Retraction of Product / Process Change Notification (PCN)

PCN #: PCN_WL-SWTP_20210701_1_Retraction

Affected Series: WL-SWTP; 1583012xx

BEFORE CHANGE AND CONTINUED PRODUCT:

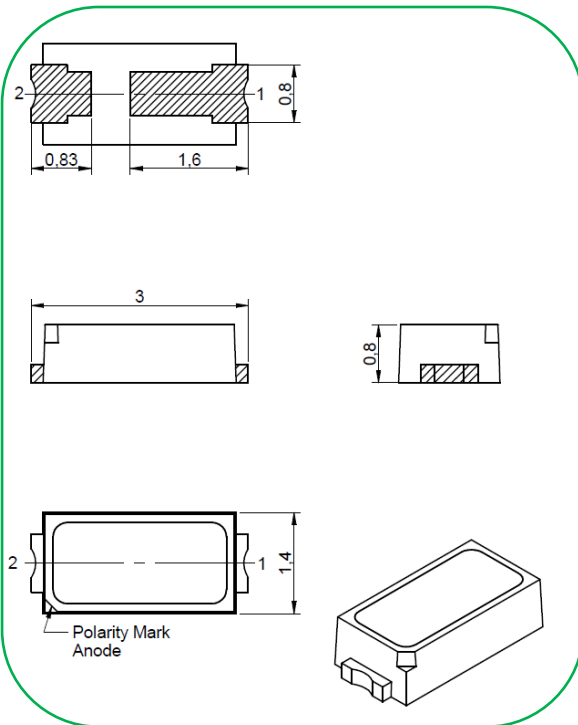
The lead frame will stay as it is before and the PCN_WL-SWTP_20210701_1 is not valid.

See technical drawing below for current and continued valid drawings.
